FILE NH-003-3(53)Clarke County **OFFICE** Preconstruction
P. I. No. 122890
DATE July 13, 2000
FROM  C. Wayne Hutto, Assistant Director of Preconstruction
TO SEE DISTRIBUTION

SUBJECT PROJECT CONCEPT REPORT

PROJECT CONCEPT REPORT

**NH-003-3(53)
CLARKE COUNTY
P.I. NO. 122890**

SR 10 LOOP / ATLANTA HWY
RECOMMENDED ALTERNATE

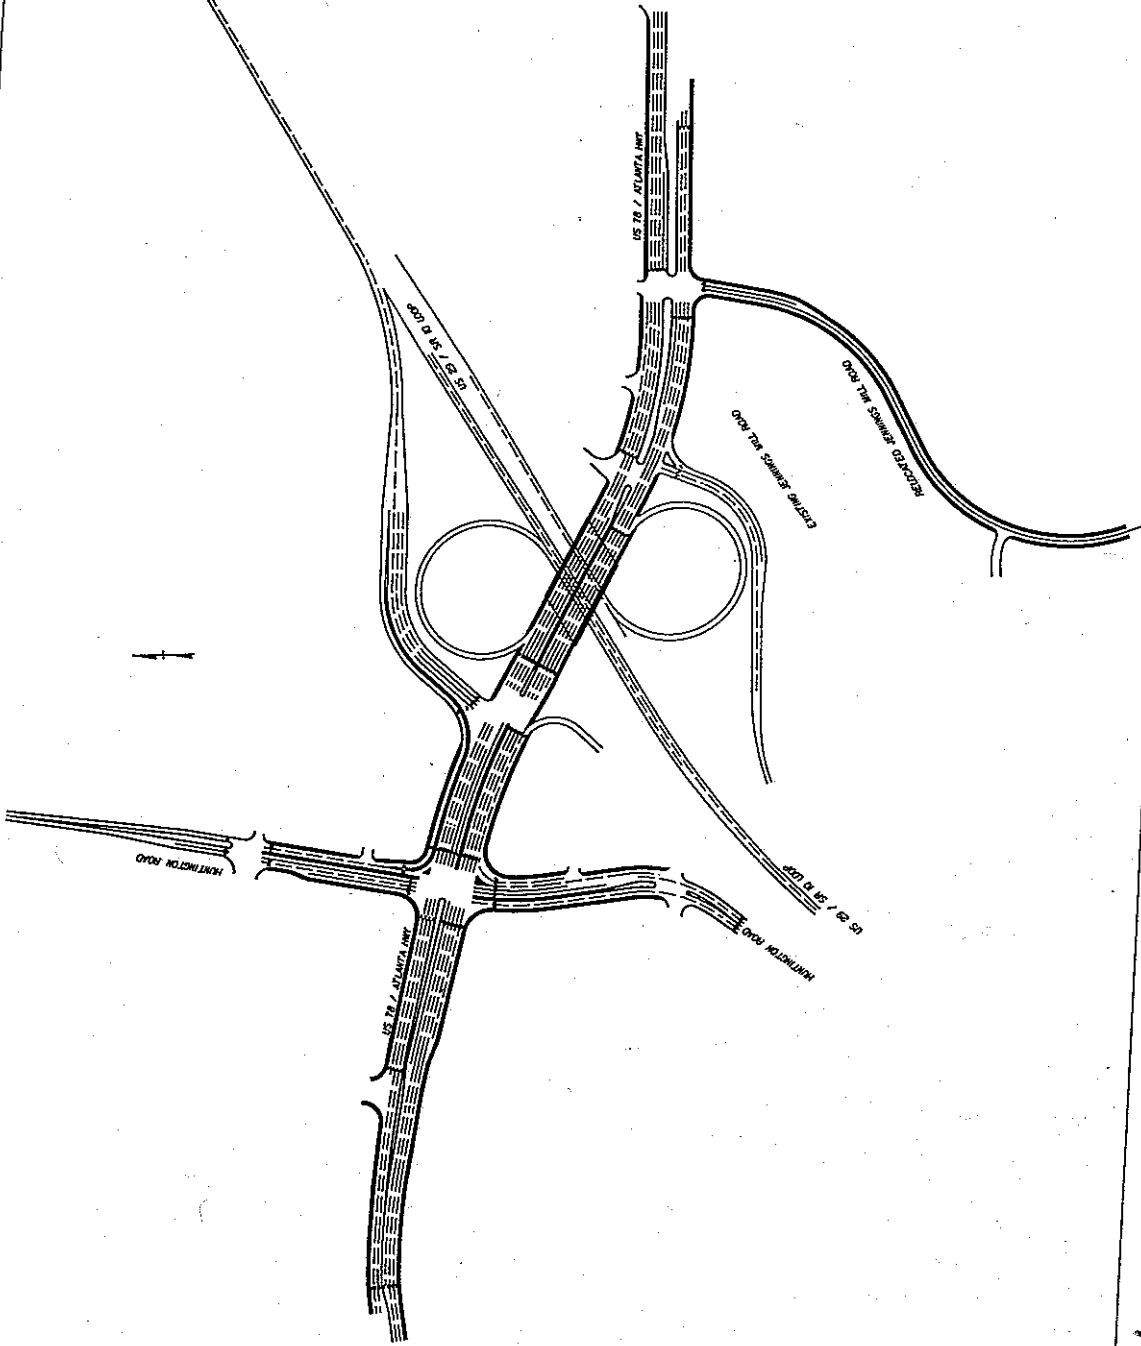
Thank you for inviting staff from Athens-Clarke County to attend the Concept Meeting on November 18, 1999 to review the planned improvements to the intersection of the SR 10 Loop @ Atlanta Highway. Overall, Athens-Clarke County is supportive of the concept of improving this interchange area and Athens-Clarke County has worked with the Athens-Clarke-Oconee Transportation Study (ACORTS) to include this project in the 20-year Long Range Transportation Plan and FY2000-FY2002 Transportation Improvement Program (TIP).

The current Long Range Transportation Plan and TIP contains a project that would improve the area; however, the concepts presented in these documents differ greatly from the concept reviewed during the November 18, 1999 meeting. The TIP project involves constructing a cloverleaf ramp on the north side of Atlanta Highway to eliminate the need for vehicles to make left-turns to and from points south along the SR 10 Loop. In addition, the concept was to be accomplished using the existing right-of-way. Based on conversations during the November 18th Concept Meeting, the current concept will require a large right-of-way acquisition, estimate at over \$8 million dollars. Athens-Clarke County requests that the currently adopted proposal in the Long Range Transportation Plan and the TIP be evaluated by GDOT.

In summary, Athens-Clarke County staff has serious and significant reservations regarding the currently proposed concept. If you have any questions about the Athens-Clarke County's comments on the proposed concept, please feel free to contact David Clark, Director of Transportation & Public Works at (706) 613-3440.

1. It was agreed that comments 1, 4, and 5 are no longer an issue due to the removal of the new exit/entrance ramps from the preferred concept.
2. In response to comment 2, ARCADIS Geraghty & Miller will investigate the possibility of replacing the SR 10 Loop northbound exit ramp with a loop in the northeast quadrant. This loop ramp and the relocated SR 10 Loop northbound entrance ramp will align with the relocated Jennings Mill Road. GDOT will provide ARCADIS Geraghty & Miller with the modified right-of-way data, including the additional right-of-way that has been acquired in this quadrant. It was agreed that this new loop ramp will require a collector/distributor system to prevent a weaving problem with the existing SR 10 Loop entrance loop ramp.

3. In response to the weaving issue addressed in comment 3, ARCADIS Geraghty & Miller will modify the intersection of Atlanta Highway and SR 10 Loop southbound exit ramp. The modified concept

4. GDOT determined that the direct alignment of Huntington Road with the SR 10 Loop southbound exit ramp, mentioned in the second half of comment 3 and comment 7, will most probably require a collector/distributor system with the Jennings Mill interchange included in Athens-Clarke County's Long Range Transportation Plan. It was agreed that this was not in the scope of this project and will need to be addressed separately.
5. The planning concerns addressed in comment 6 will be discussed with GDOT Planning.
6. GDOT will investigate the paperwork required to supplement the ARCADIS Geraghty & Miller work order by a maximum of 20% to finalize the above mentioned changes.
